The report on harbour porpoises (OWEZ\_R\_253\_T1\_20120202\_harbour\_porpoises.pdf) is written within the framework of this monitoring program.

**TNO 2012 R10080**

**TNO review of IMARES report 'Assessment of the Effects of the Offshore Wind Farm Egmond aan Zee (OWEZ) for Harbour Porpoise (comparison T0 and T1)'**

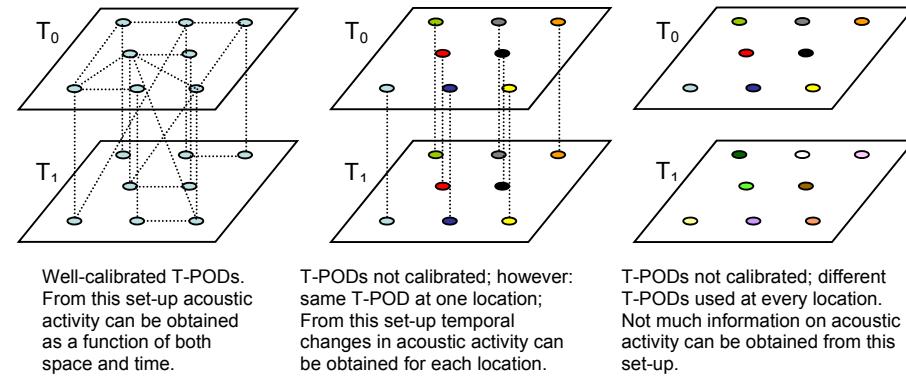
Unfortunately, some of the T-PODs were lost during the experiment. They had to be replaced by other devices. The original T-PODs were of the type V3 whereas the replacement T-PODs were of the type V5. This means that the original experimental set-up (‘same T-POD at same location’) could no longer be maintained. The result is the set-up according to the right picture of Figure 2 (‘various T-PODs at same location’). As a consequence, a careful intercalibration between the various T-POD devices to be used at the same measurement location is required in order to satisfy the original experimental set-up requirements (middle picture of Figure 2).

In summary: because individual T-PODs may differ, it is important to use the same T-POD at each particular location throughout the experiment, or, if this is not possible, to carefully intercalibrate the T-PODs to be deployed at the same location.

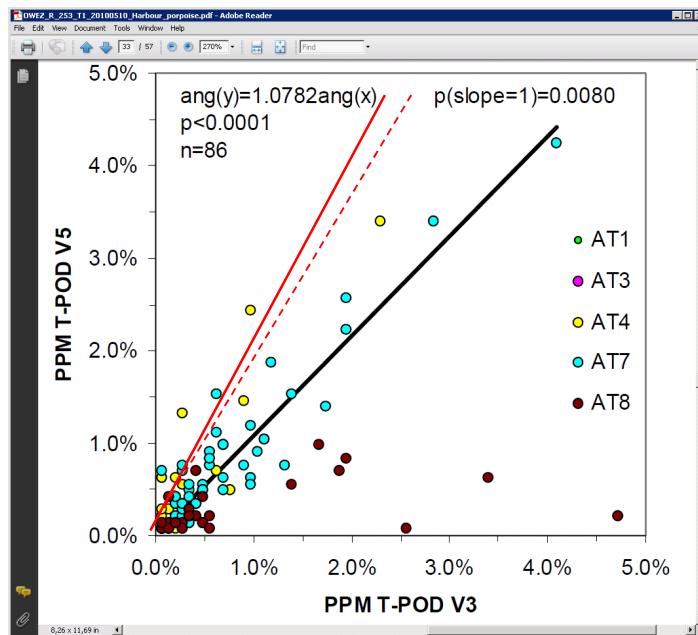
Figure 3 (which is a copy of Figure 17, p.36 in [1]) displays the result of the overall V3-versus-V5 calibration. From this figure, we get the strong impression that at location AT4, the V5 version is much more sensitive than the 8% that has now been adopted for PPM, see the yellow dots. In particular, it seems that if location AT4 would have been excluded from the analysis (as was location AT8), then the general intercalibration of V3-versus-V5 would be close to the line  $y = x$  (i.e., mainly based on the intercalibration at location AT7), meaning that V5 and V3 are equally sensitive at AT7 outside the wind farm. However, the individual AT4 V3-versus-V5 calibration (red dashed line, added by TNO) would be close to the line  $y = 2x$  (red solid line, added by TNO). It means that V5 seems to be almost twice as sensitive as V3 at AT4 within the wind farm.

IMARES has commented on our question to clarify this issue at location AT4 as follows: 'The short answer to the question is that yes, it appears that the slope of AT4 is higher than 1, but this was not statistically significant and hence not discussed' (email dd. 7 June 2010), see also p.44 of [1]. Note that AT4 is a very important location as it is one of the two locations inside the wind farm. We therefore had expected a more elaborate discussion, e.g., an explanation why the effect was not statistically significant (e.g., not enough data available?).

Note that the intercalibration of V3 and V5 type T-PODs could only be carried out for five of the eight locations, see Figure 3. However, from the figure it is clear that almost all available data refers to three locations, of which location AT8 had to be discarded (too many outliers). As a consequence only two locations remained: one inside the wind farm area, AT4, and one outside the wind farm area, AT7.

In conclusion: Figure 3 suggests that the two TPODs used at location AT4 inside the wind farm had a larger difference in sensitivity (higher sensitivity during T1 than during T0) than the factor of 1.08 as applied by IMARES.

Concerning figure 17 TNO states that “we get **the strong impression** that at location AT4, the V5 version is much more sensitive than the 8% that has now been adopted for PPM, see the yellow dots.”

It is difficult to interpret if a sensitivity is significantly different or not for a specific station / T-POD based on looking at a figure. IMARES has therefore done a detailed analyses, which can be found in the report. The results show that **AT4 does not have a statistically significant effect**. It did show that AT8 did have a significant effect and therefore it was removed in the later analyses (see below).

For PPM there were significant differences among the station-specific slopes ( $F_{4,108}=11.61$ ;  $P<0.0001$ ), but this significant difference was entirely due to the observations from AT8. **There were no significant differences among the station-specific slopes when excluding observations from AT8 ( $F_{3,82}=1.74$ ;  $P=0.1654$ )**. PPM was significantly higher (~8%) for v5 than v3 when observations from AT8 were not included in the intercalibration regression (Figure 17).
